List of changes:

1 - WINDOW JAMB DETAIL
 EXISTING BUILDING CONDITIONS

Architect / Originator: Tate Harmer	Unit G182, Stamford Works, 3 Gillet Street, London N16 6JH Tel: +44 (0)207 241 7481 Email: studio@tateharmer.com	Do not scale. All dimensions to be checked on site. This drawing is copyright.
Client: Platinum Land	8 Querpel House, 1 Duke of York Square Kings Road, London, SW3 4LY	Date of Origin: 28.11.17 Drawn By: TS
Project: Belsize Park Firestation		Scale: 1:5
Drawing Title: TYPICAL WINDOW PLAN DETAILS		Drawing Status: Planning
Client Sign Off:	Drawing Number: BFS THA PR AL 621 P5	Revision:

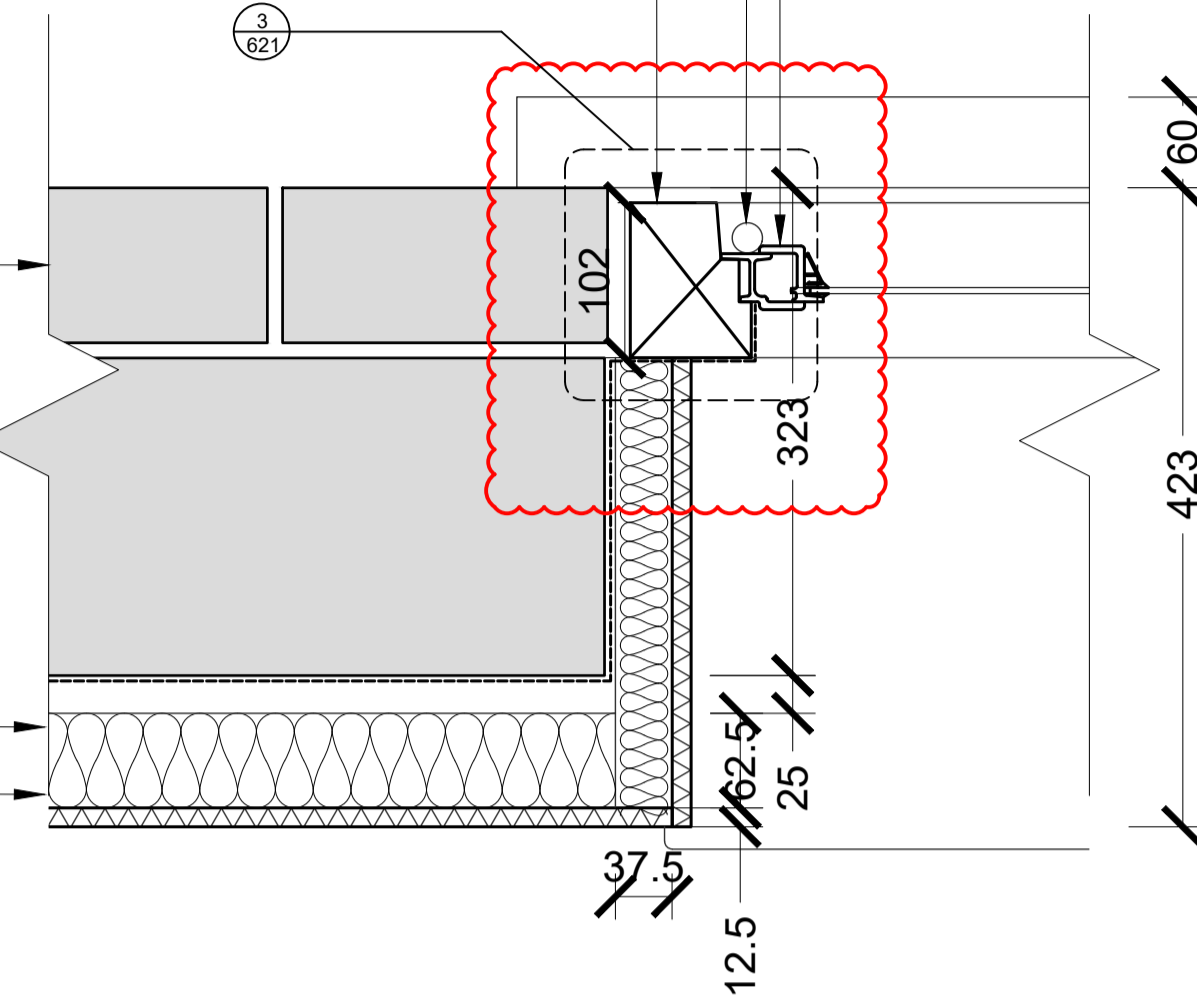
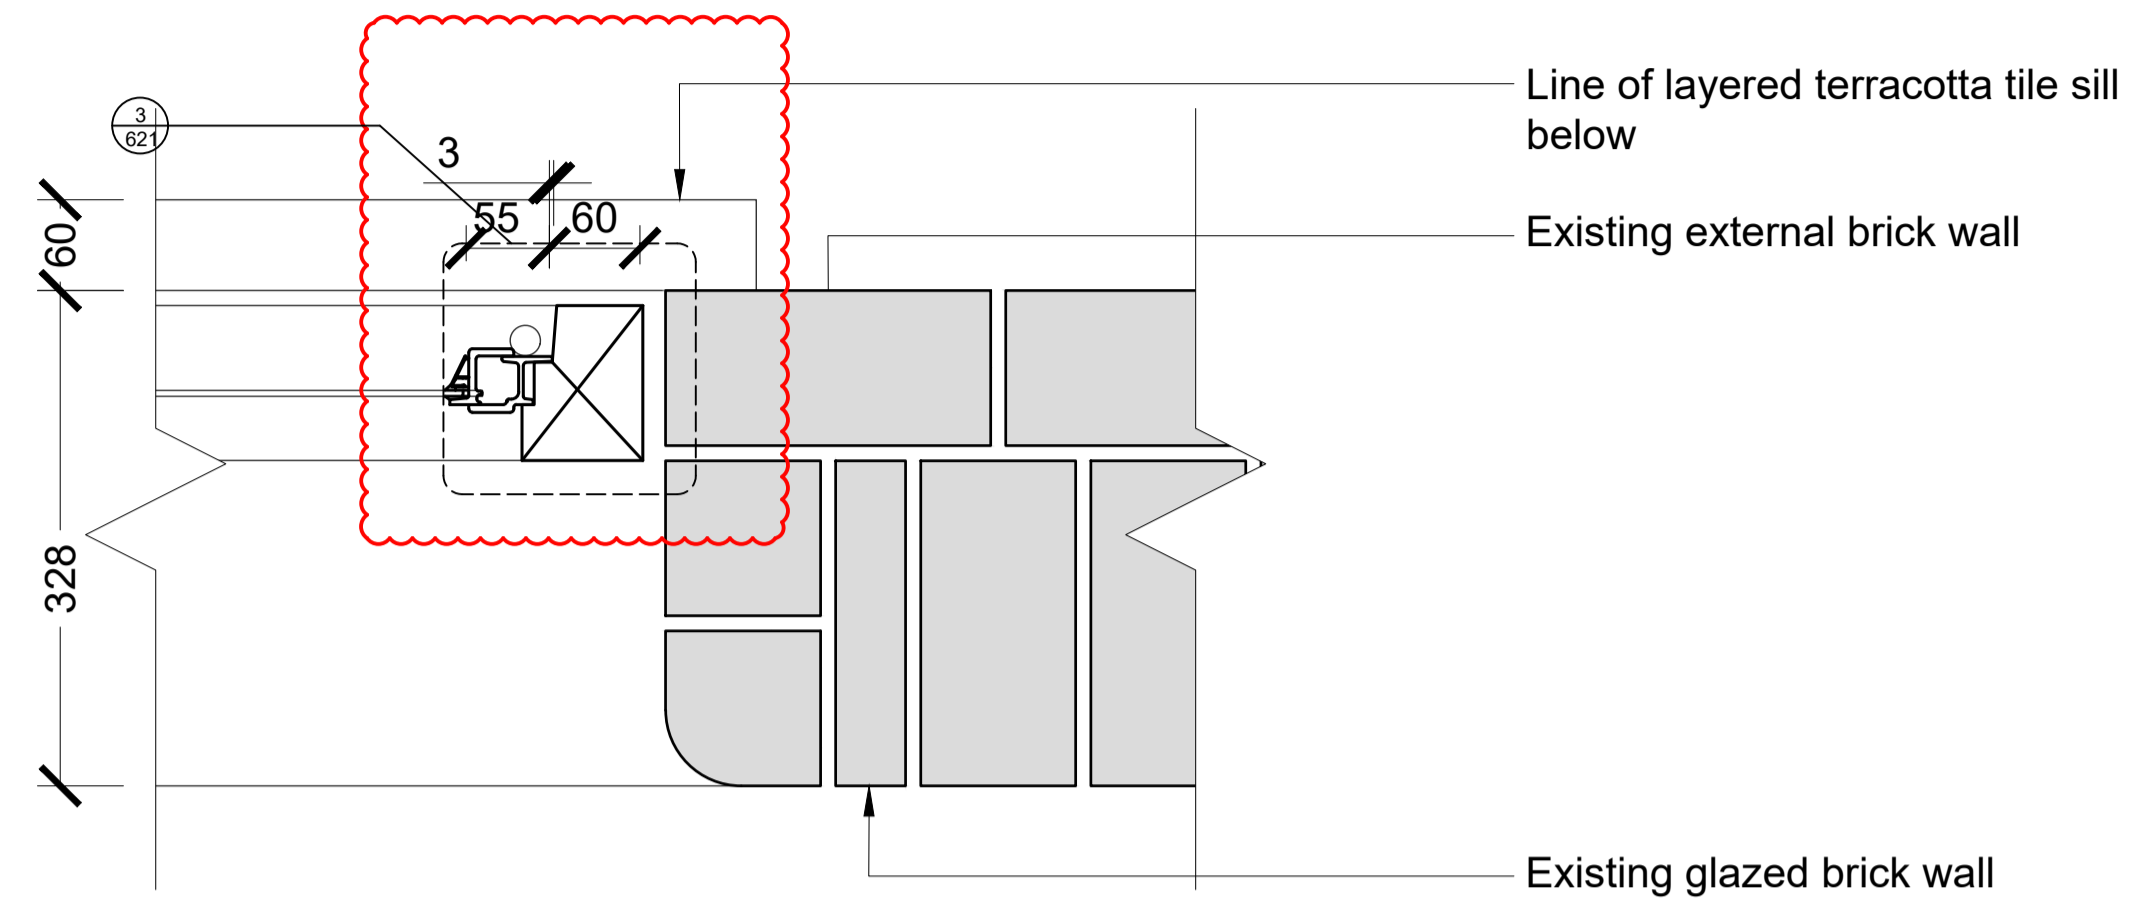
- Window jamb details updated.
